**Eugene School District 4J
ROOSEVELT MIDDLE SCHOOL**
680 East 24th Avenue
Eugene, OR 97405
CIP No. 410.566.001

ADDENDUM NO. 6

This Addendum forms a part of the Contract Documents and modifies the original Bidding Documents dated February 18, 2015 and subsequent addenda as noted below. Acknowledge receipt of this Addendum in the space provided on the Bid Form. Failure to do so may subject the Bidder to disqualification.

C3 STAIR 1 - FIRST FLOOR PLAN
1/2" = 1'-0"

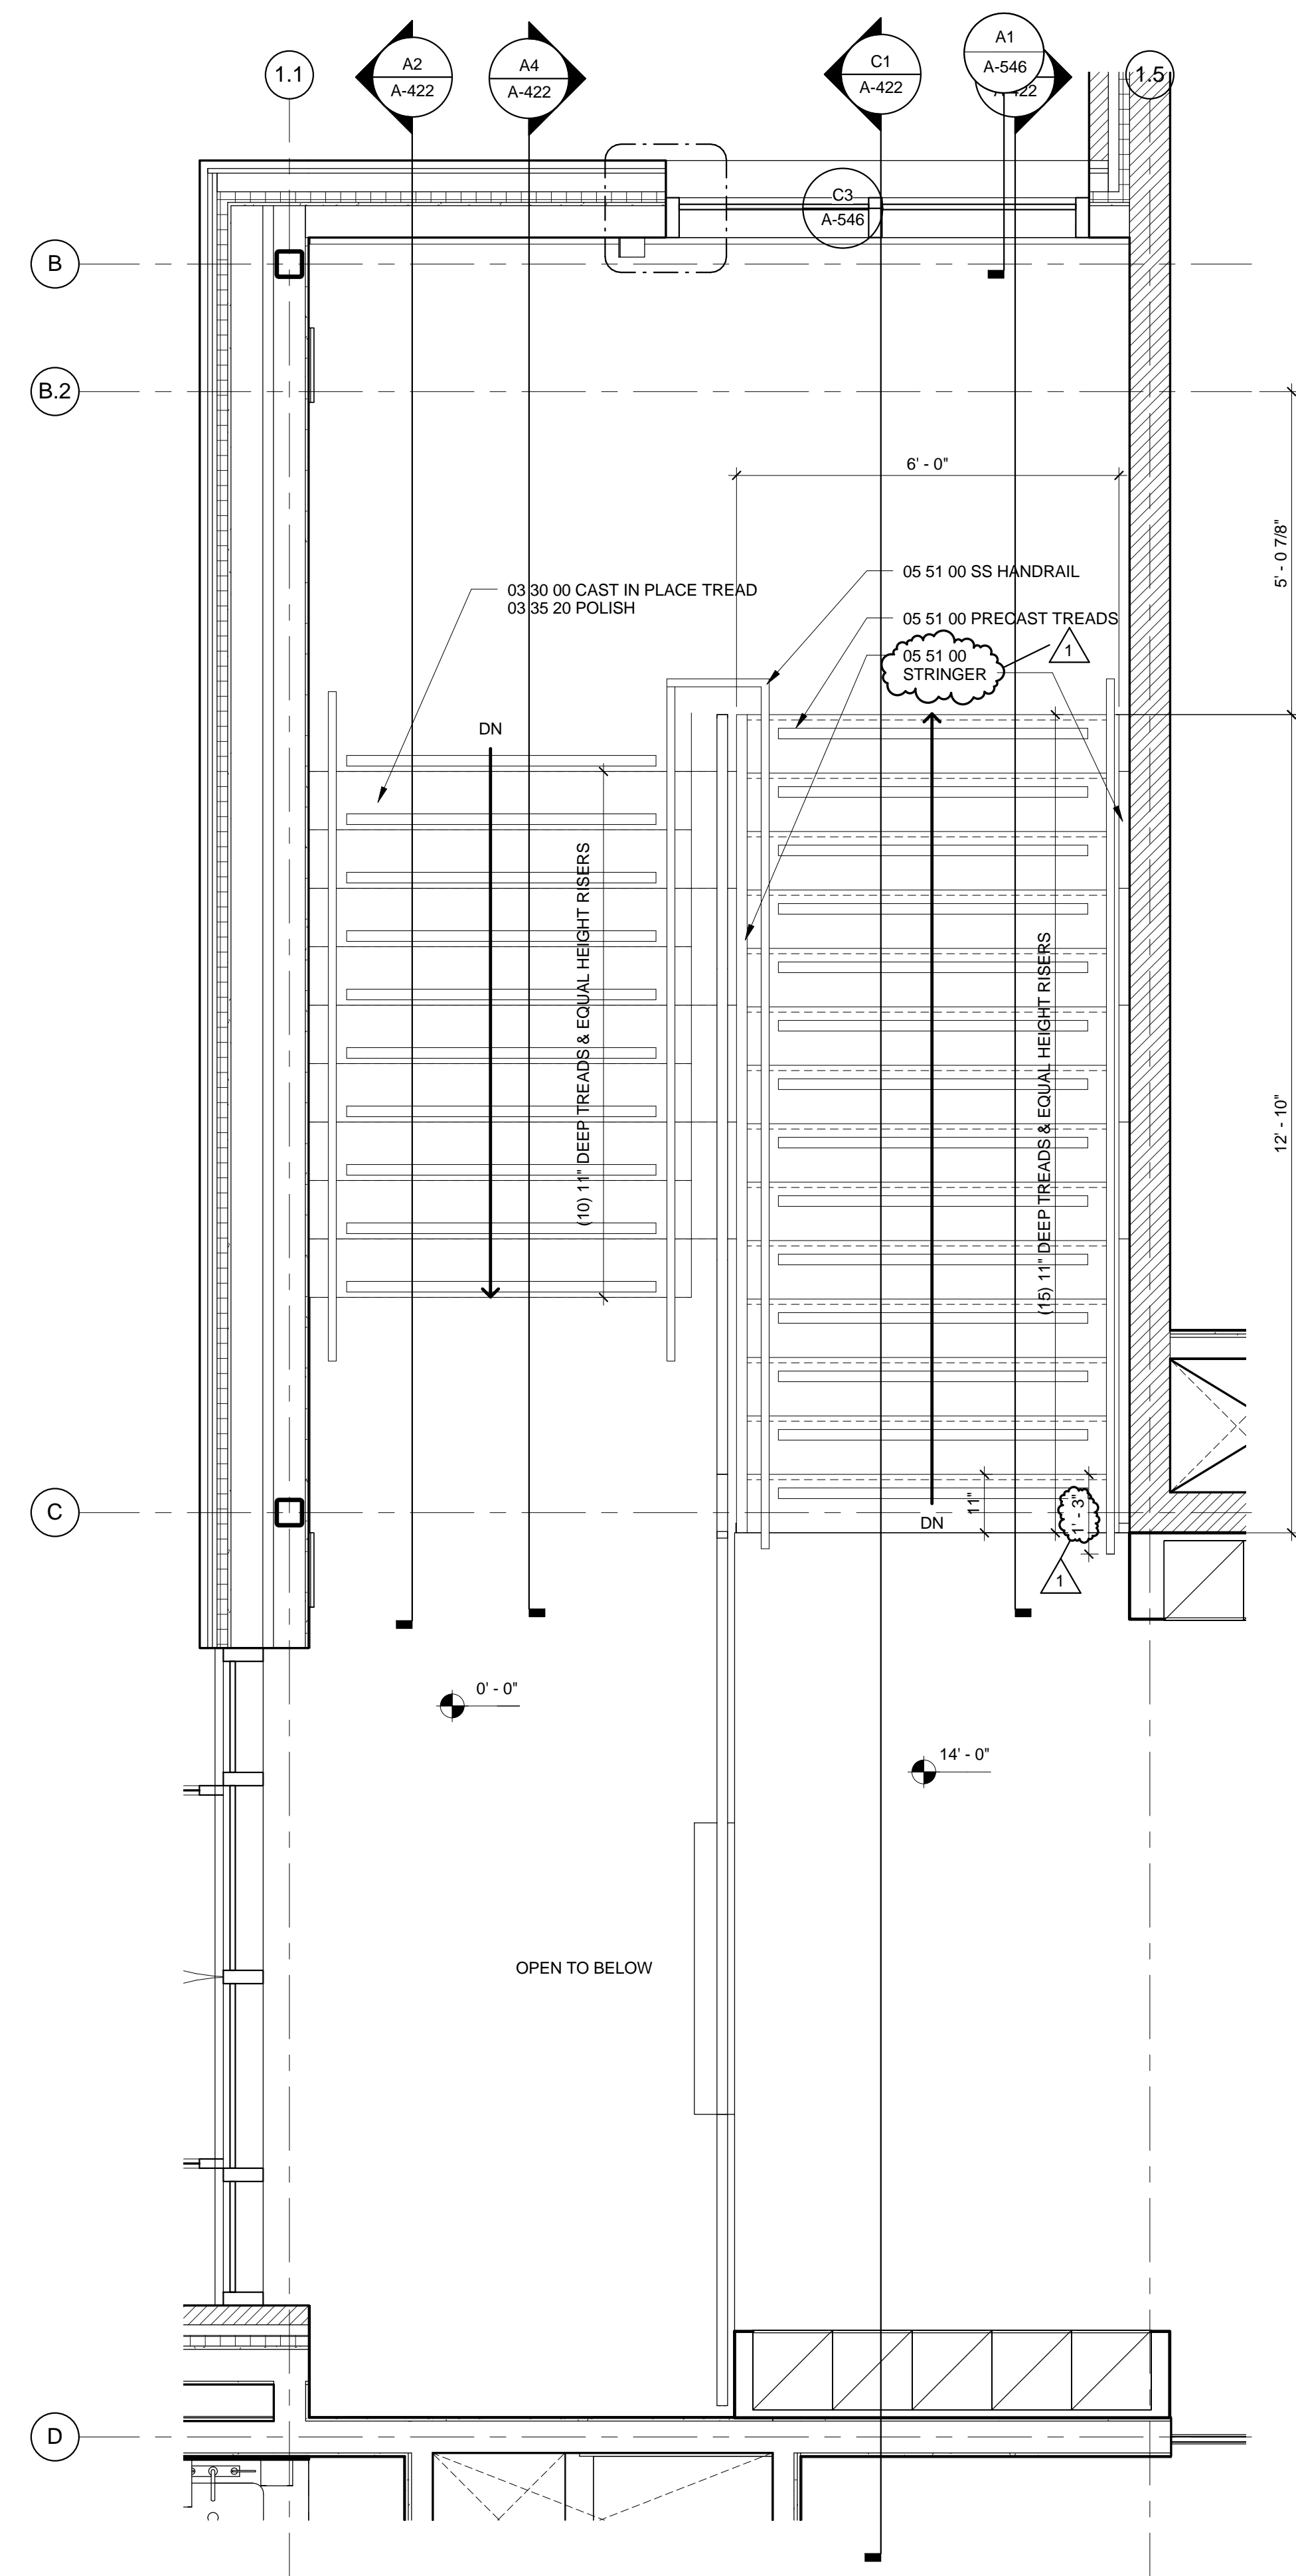
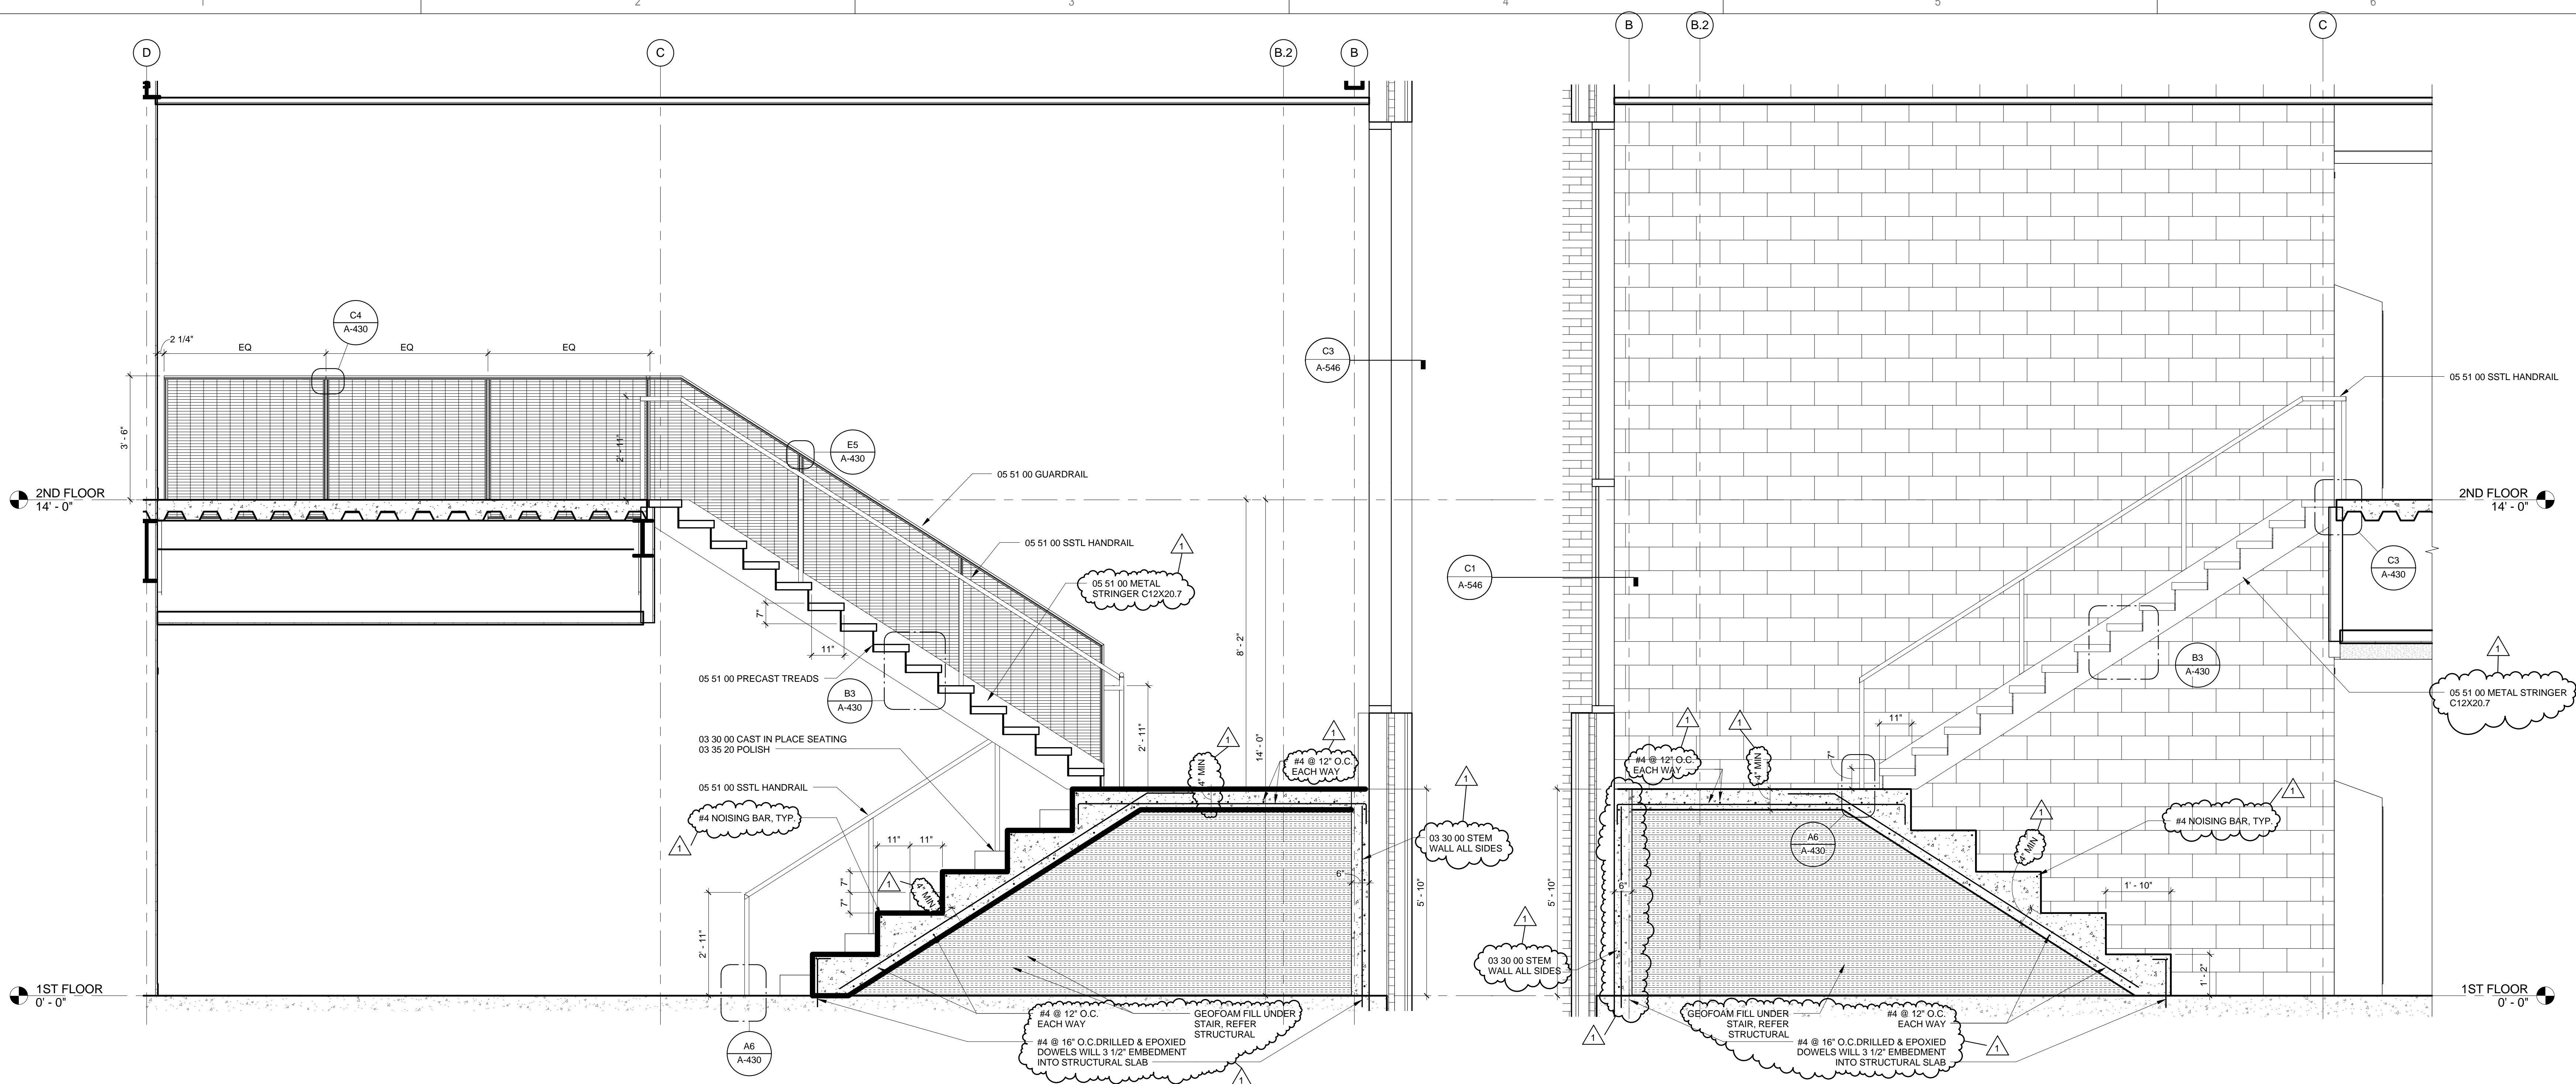
- A. Replace Sheet with attached revised Sheet A-421: B6/ A-421 Add description to stringer.

C1 STAIR 1 - SECTION D
1/2" = 1'-0"

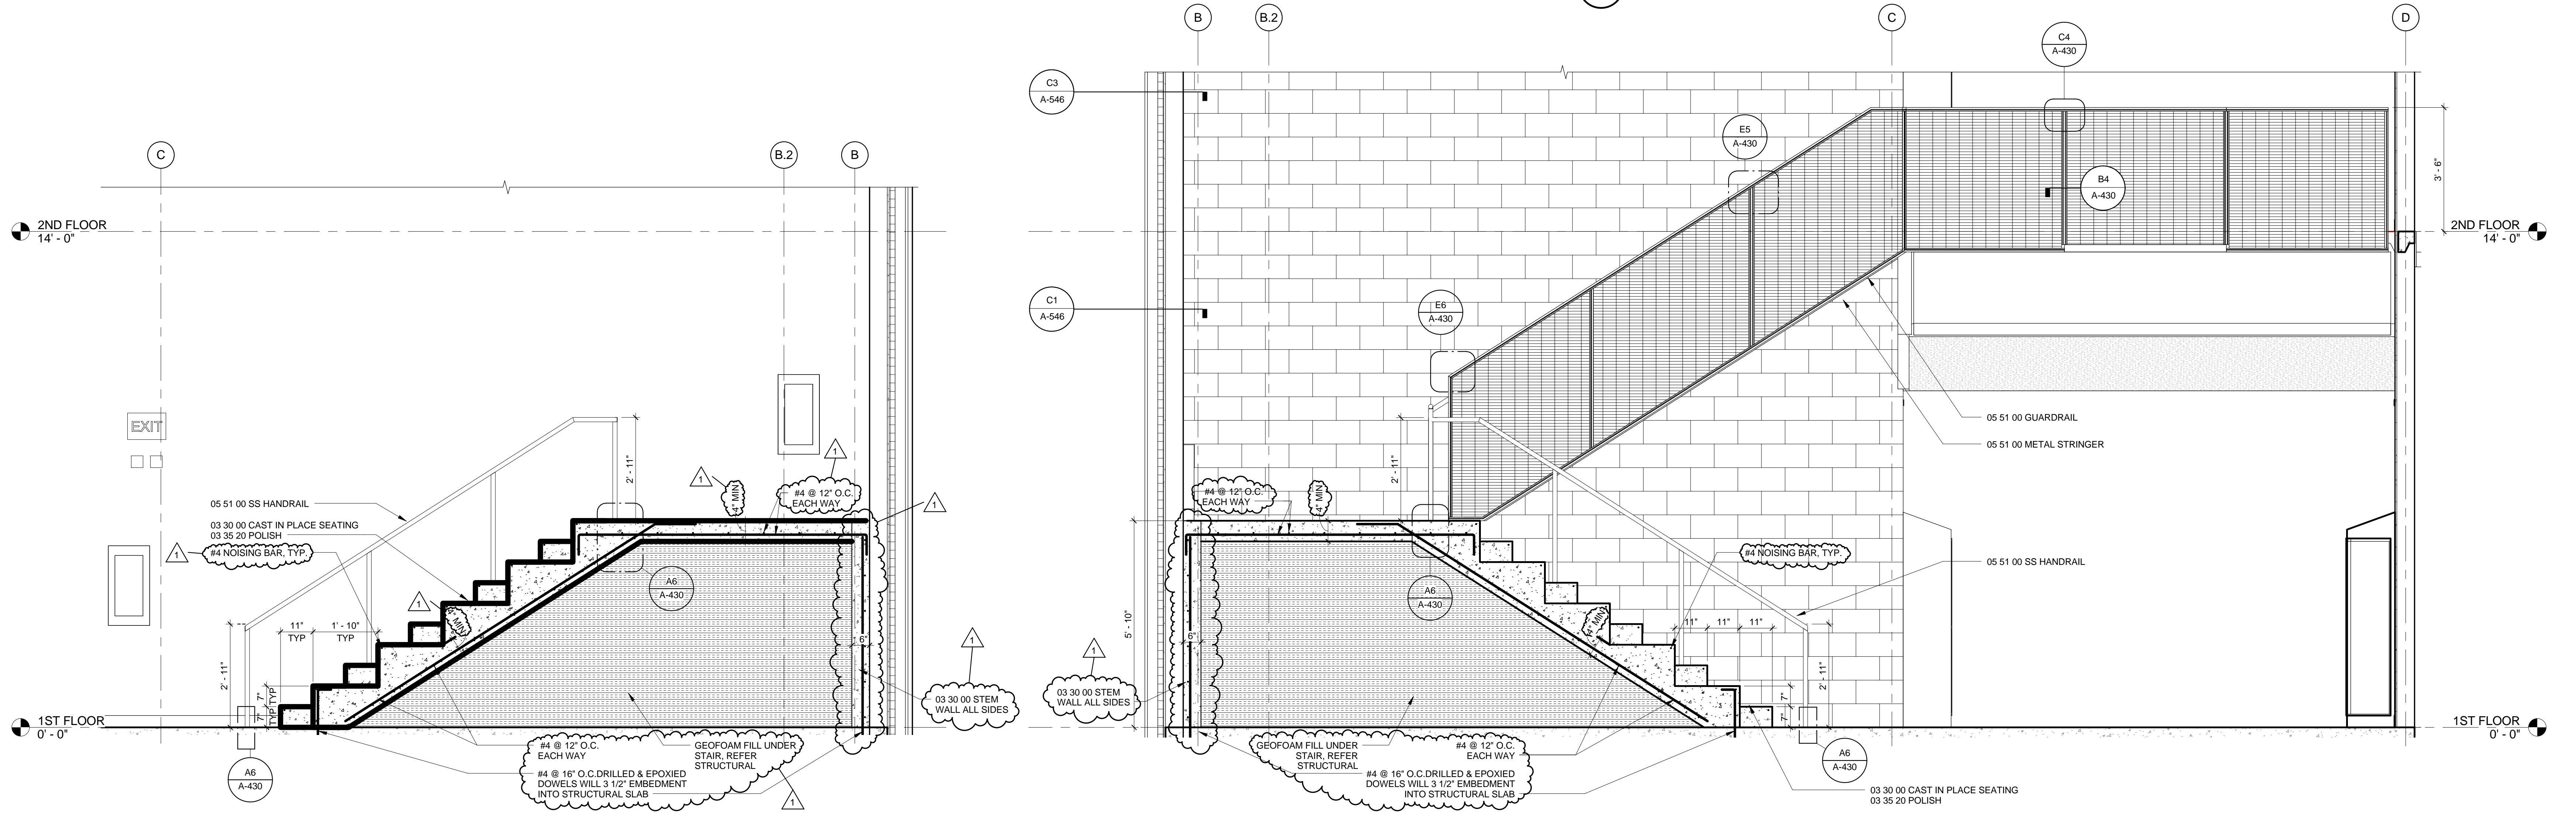
- A. Replace Sheet with attached revised Sheet A-422: C1, C4, A2,A4/ A-422: Add description to stringer. Add additional information to concrete landing
